# Alignment Marker Mapping and Insertion - Supporting Material for Comment #3 and #2

Adrian Butter (on behalf of the P802.3bs Logic Ad Hoc team)

# D1.2 Comments Regarding Alignment Markers

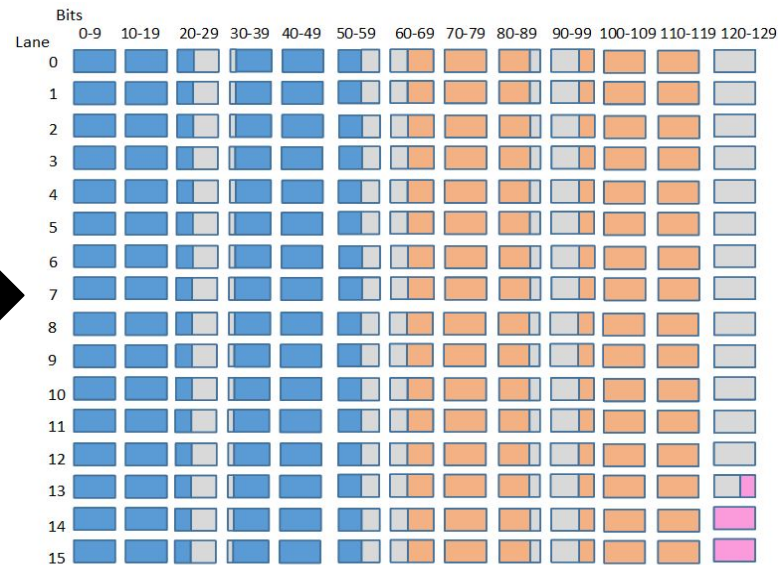
Change alignment marker format from:

- Common marker (64 bits)
- Unique marker (56 bits)
- Pad (136 bits)
- Next 257-bit block

... to:

- Common marker (48 bits)
- Unique marker (48 bits)
- Pad (520 bits)
- Next 257-bit block

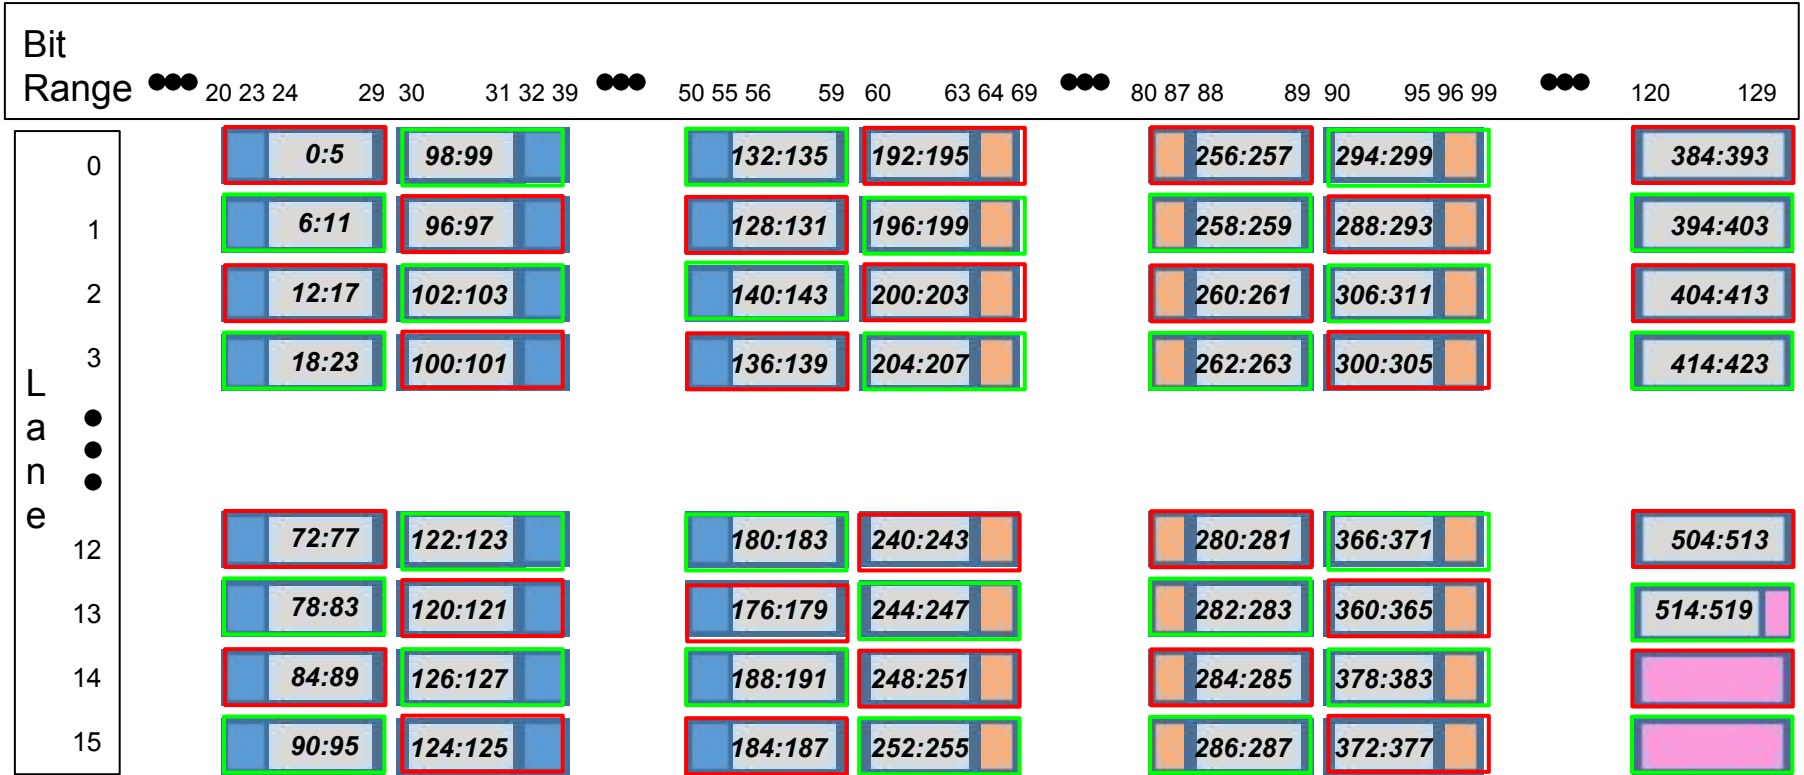
PRBS9 padding is organized in the following manner:

$x:y$  = PRBS9 bit range for the current Alignment Marker insertion operation (bit 0 generated first).

## Comment #3 Update - 119.2.4.4 Paragraph 2

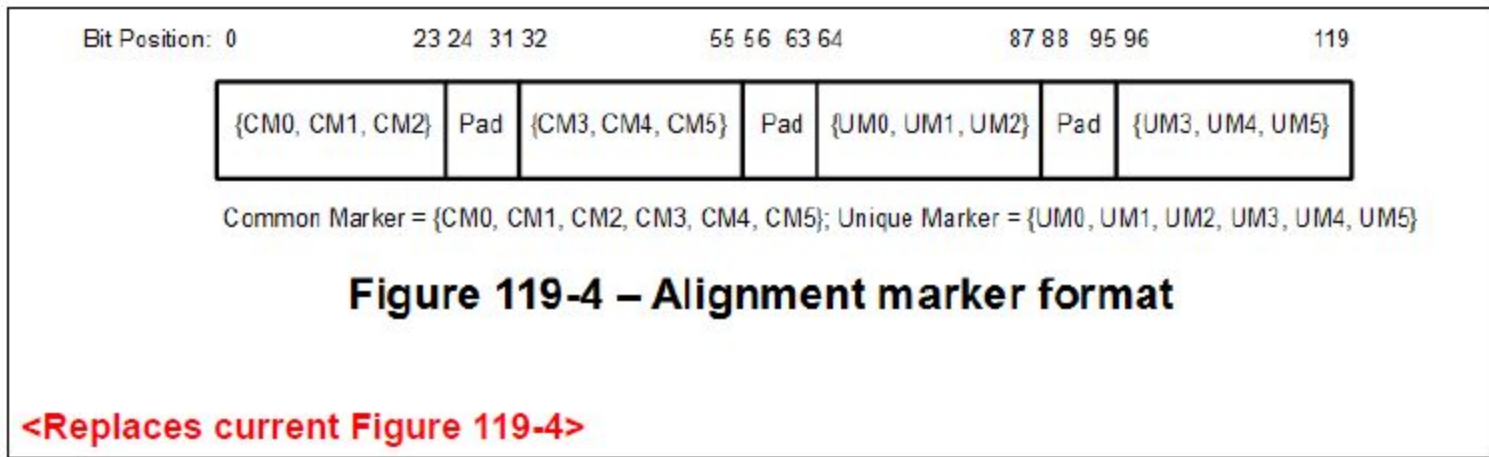
Room for the alignment markers group is created by the transmit PCS (see 119.2.4.1). Special properties of the alignment markers ~~are group is~~ that ~~it is~~they are not scrambled, does not conform to the encoding rules as outlined in Figure 82-5 and ~~is are~~ not transcoded. This is possible because the alignment markers ~~are group is~~ added after encoding, transcoding, and scrambling, and removed before descrambling, transcoding, and 64B/66B decoding. The alignment markers ~~are group is~~ not scrambled, which allows in order to allow the receiver to directly search for and find the individual alignment markers, deskew the PCS lanes, and reassemble the aggregate stream before descrambling is performed. Additionally, the fixed 96-bit portion of the alignment markers ~~is themselves are~~ formed from a known pattern that is defined to be balanced and with many transitions and therefore scrambling is not necessary. ~~The group of alignment markers shall be inserted so they appear every 163 840 257 bit blocks. The variable tx\_scrambled\_am is created by inserting the group of alignment markers in the variable tx\_scrambled. Alignment marker mapping and repetition rate are shown in Figure 119-5 and Figure 119-6.~~
